Begbroke and Yarnton Green Belt Campaign (BYG)

Deadline 3, BYG WR: Comments on the Applicant's Responses to the ExA's First Written Questions (ExQ1)

Deadline 3. BYG Comments on Historic England`s Response (REP2-056) to the ExA`s First Written Questions (ExQ1)

Following: photograph of a navigation screen using Google Maps in the vicinity of Blenheim Palace, showing how the landscape that would be covered in solar panels would be seen by the car driver.

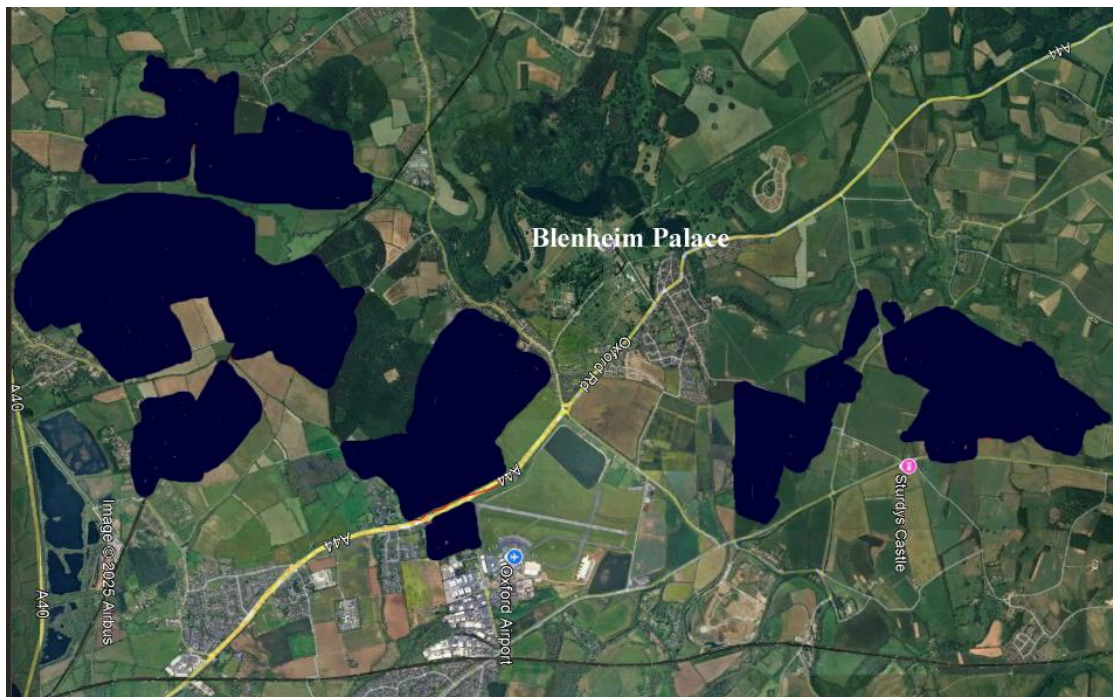
4. Furthermore, and yet to be appreciated, is the impact the proposed BWSF development would have on all car drivers and others approaching Blenheim or its vicinity who are using Google Maps for navigation in Live View. They will be seeing the same Google Earth image as seen from the air (as shown above).

5. A recent Martin Lewis poll in June (38,953 votes) would suggest that, for those drivers using navigation systems, around half are using Google Maps. Many others following proprietary inbuilt satellite navigation will also be using Google Earth. A photograph of the standard navigation screen for a Tesla is shown below revealing the extent of the landscape that is visible while driving the car.

7. West Oxford District Council (REP1-081 6) and Historic England (REP1-085 1.14-1.16) have both indicated that the Applicant has understated the impact of the development on those observing the site at ground level. We would argue that the Applicant has also failed to address the visibility of the site to those in the air, and to those using Google Earth while travelling by car and by other means of transport.

8. The industrialisation of the landscape surrounding Blenheim would be clearly visible to both. New hedgerows or woodland would not, of course, mitigate the impact. The Applicant would have failed in its stated objective to "*avoid any unacceptable direct or indirect effect upon the Blenheim Palace World Heritage Site*".
